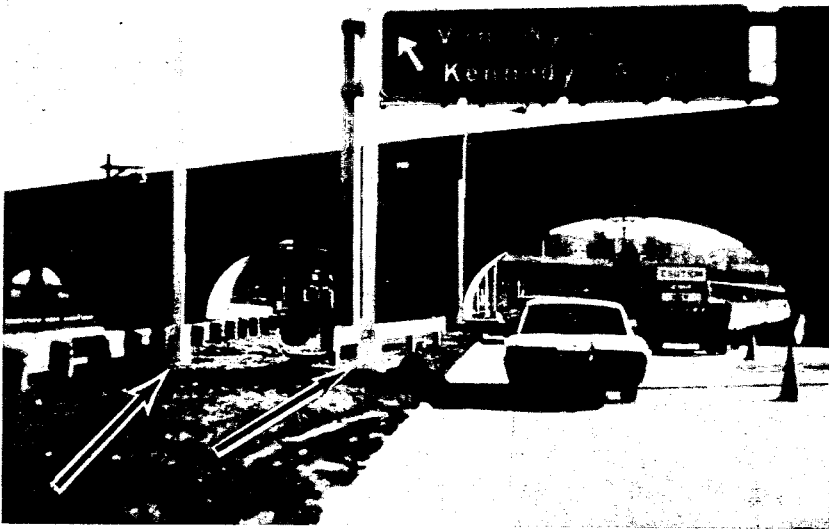
Here you see where they could use one pole and put an arm on either side, but they have two poles and they put one exactly where it is going to be hit, in front of the guardrail and right near the edge of the shoulder.

It made me mad as I watched them build this stuff. I read a book that tells them to put it 10 feet beyond the shoulder. Here they are putting it right back in the same old place. They are pouring a brand new foundation, not using the old base here. There is no excuse for it. They could have set these back. This is only a two-lane section, so they cannot say the luminaire arms are not long enough.
